# Memorandum

SUBJECT: Circumlunar Missions

DATE: JUN 29 1965

FIGURE 2.1-1

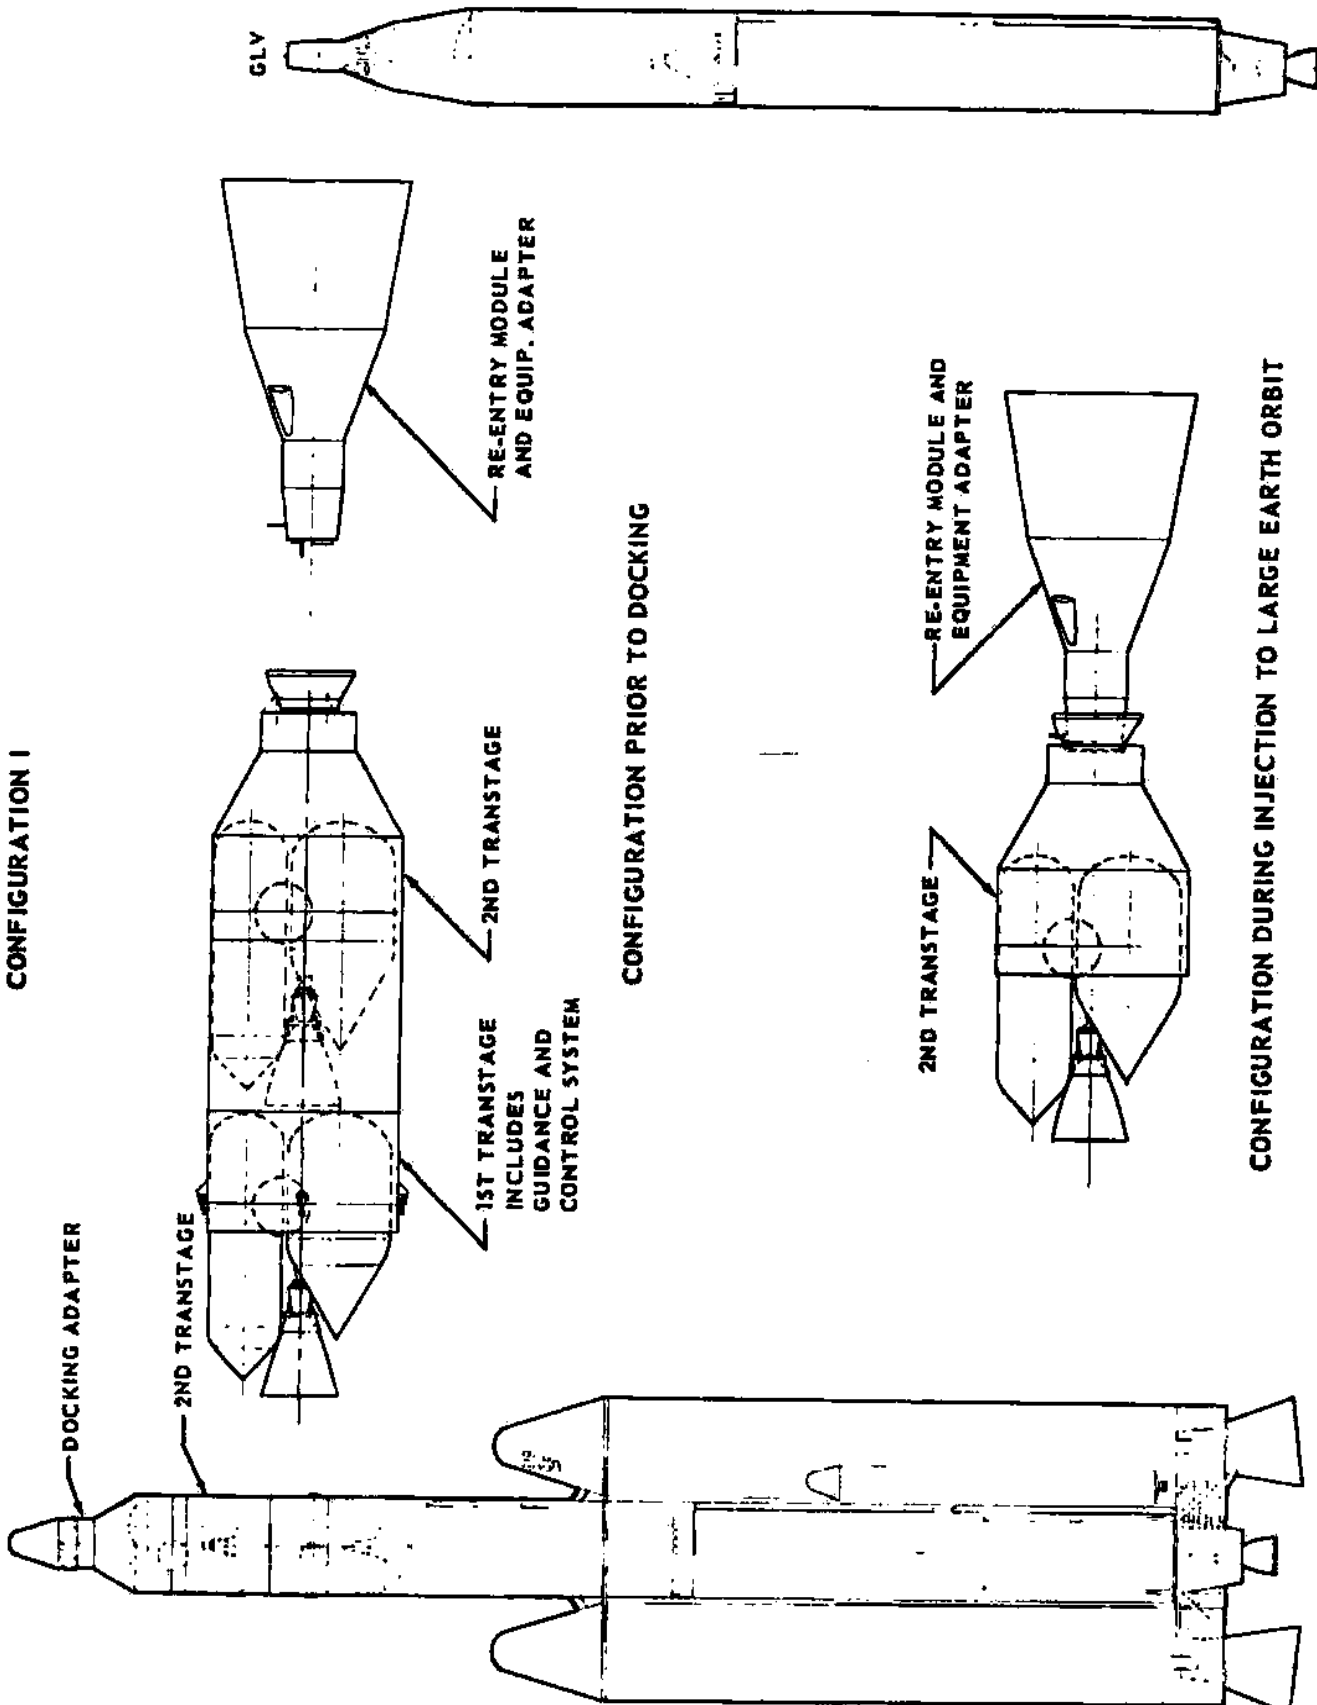
2. In this proposal the Gemini spacecraft modified for circumlunar flight is launched into earth orbit with a GLV. The Titan IIIC launches a stripped down transtage that provides the propulsion for injection to circumlunar velocities after rendezvous with the spacecraft. The general arrangement and flight hardware are summarized in enclosure (1) (Figure 2.1-1 of Attachment C).

3. The principal changes to the Titan IIIC involve using a double transtage. The first provides propulsion during launch to earth orbit and contains the attitude control and an equipment module for use during rendezvous with the spacecraft. A Gemini Target Docking Adapter is mounted on top of the second transtage.

7. No money estimates were presented by Martin or MAC; however, some preliminary estimates by GPO indicated \$350M.
8. I think the proposal is feasible, but not within the time and effort indicated. The equipment and mission are too marginal to absorb changes and additions that will be required without extensive redesign and testing.
